COMMENTS ON TEST MODEL DEVELOPMENT (JVET-J0081)

M. Zhou, W. Wan, T. Hellman, P. Chen (Broadcom)
O. Hugosson, D. Symes, A. Duenas (ARM)
E. Chai (RealTek)

Recommendations for tool selection for an initial test model

Example: Pattern Matched Motion Vector Derivation (FRUC)

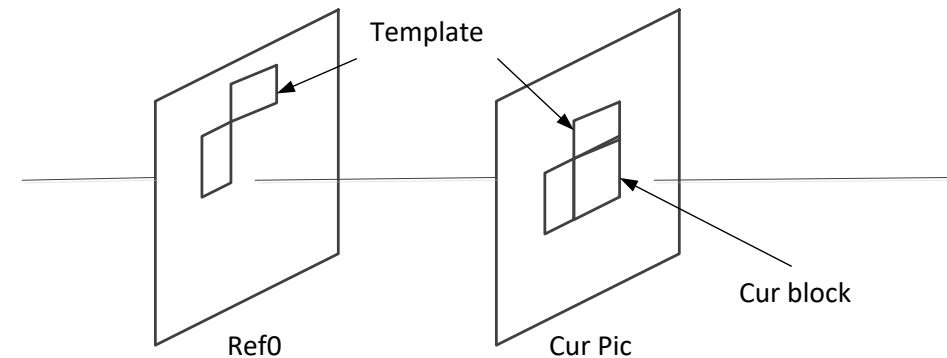
1. There several coding tools in the CfP responses which require access to the reconstructed samples from left and top neighboring blocks
2. Some of such examples are
 - 1) Template matching in FRUC for uni-prediction
 - 2) Template matching based MV candidate reordering
3. We see those tools as no-goers, since they break the decoder pipeline architecture
 - 1) The high latency dependency loop prevents an efficient implementation
 - 2) No high-throughput decoder (e.g. 4K@60) possible w/ those tools

- Bilateral matching uses only list0/list1 reference blocks
- Uni-directional template matching accesses reconstructed samples from neighboring blocks
 - Reconstructed samples of top/left neighboring blocks may not be available due to pipeline delay

Diagram of Video Decoder w/ CfP Tools

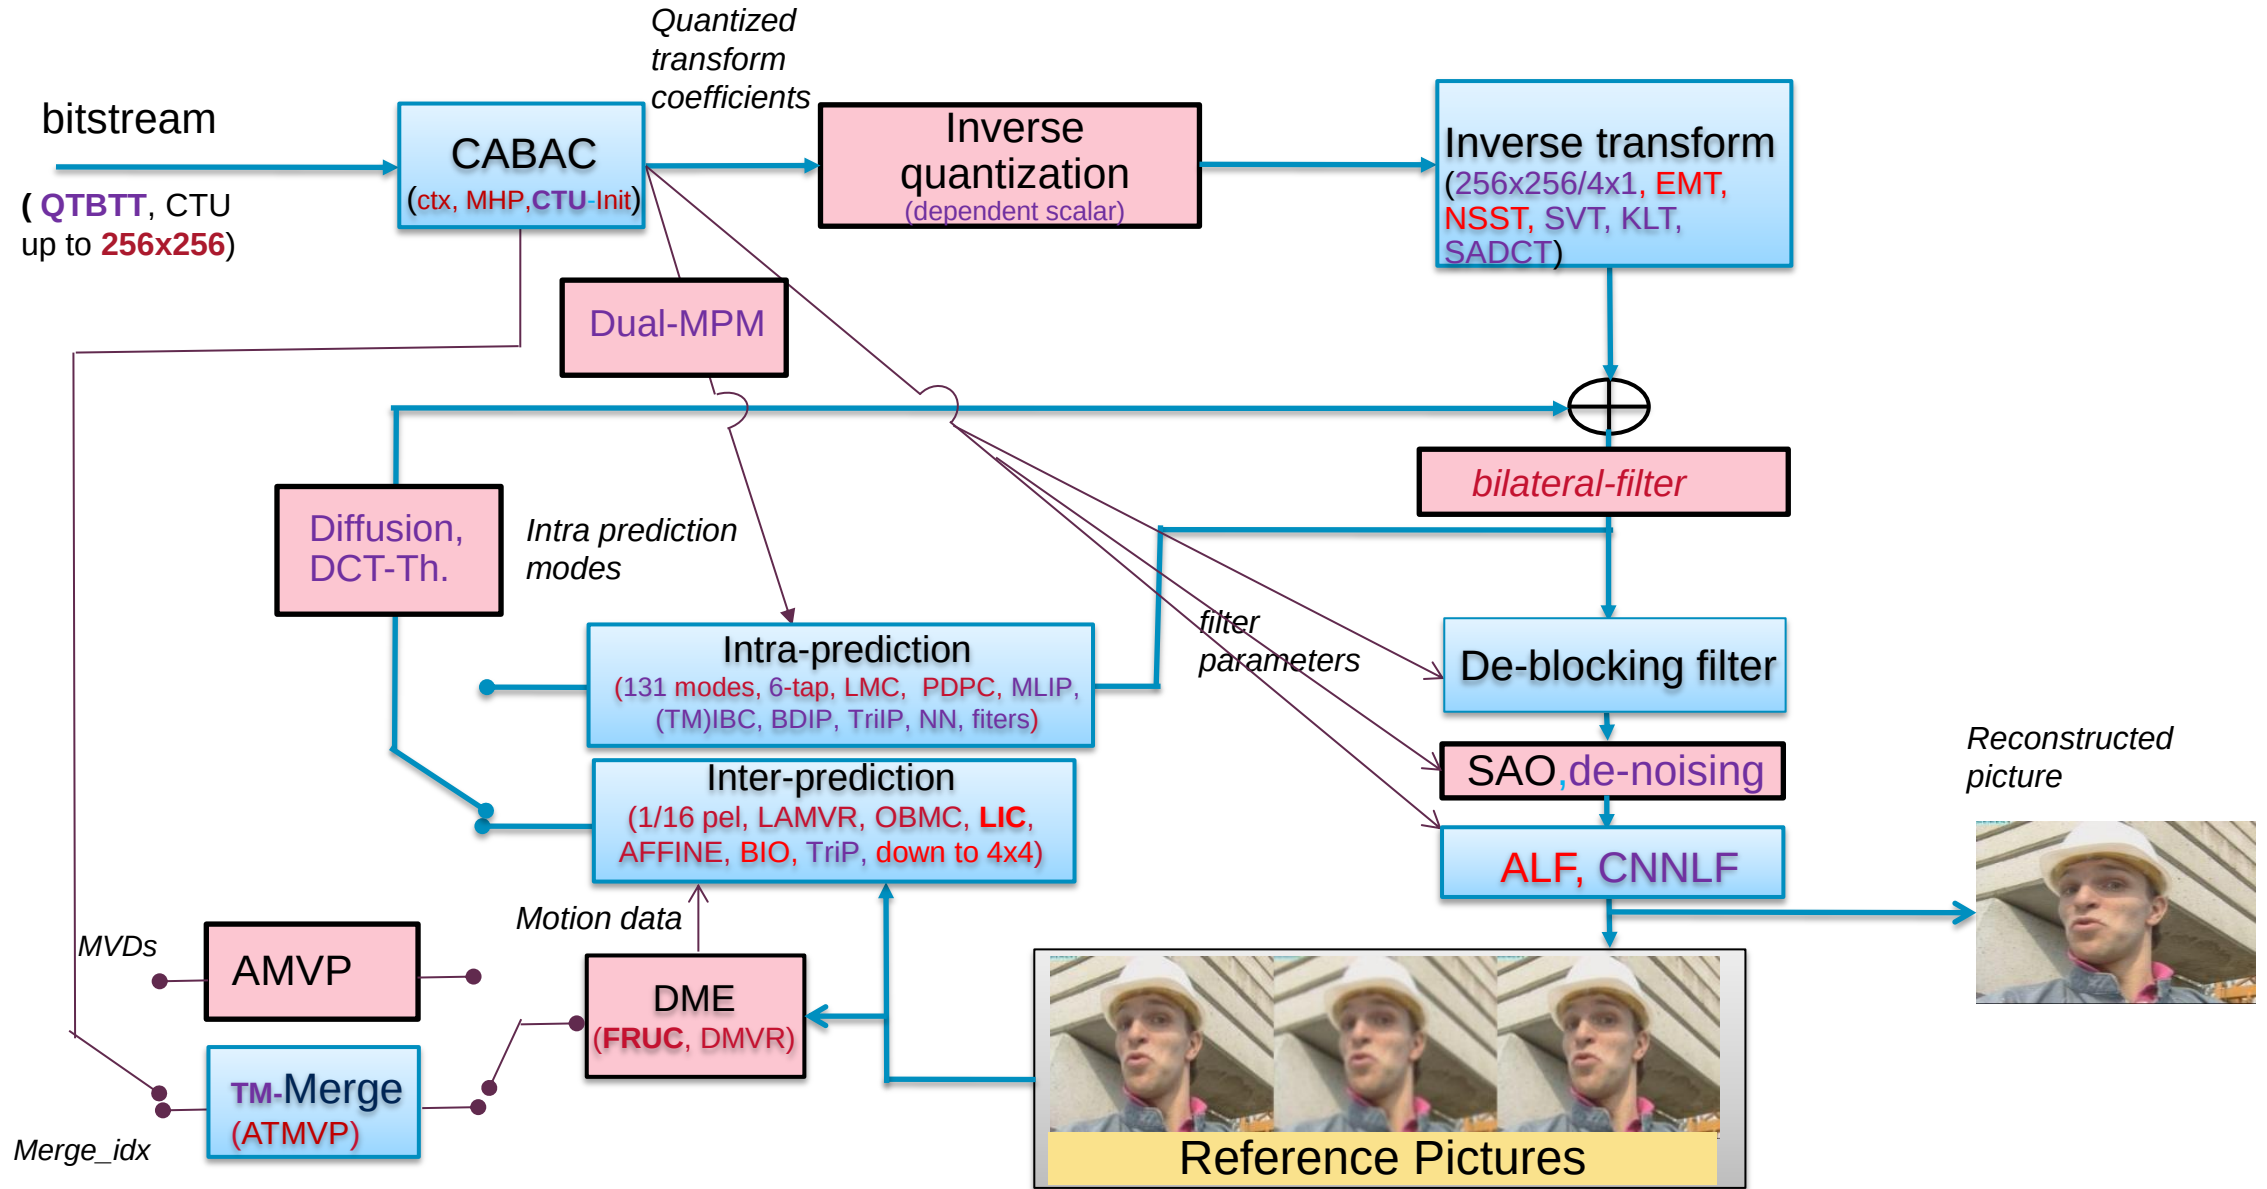
1. TU size up to 256x256 and down to 4x1/1x4 has been seen in CfP responses
2. The maximum TU size dictates the local buffer size of decoder HWAs (Hardware Accelerators)
3. HEVC has 32x32 (luma)/16x16 (chroma) maximum TU size, which enables 32x32 based decoder pipeline
4. 256x256 TU will increase decoder local buffer size by 64x
5. 256x256 transform itself is very costly
6. Small TU and intra blocks are likely to cause throughput issue
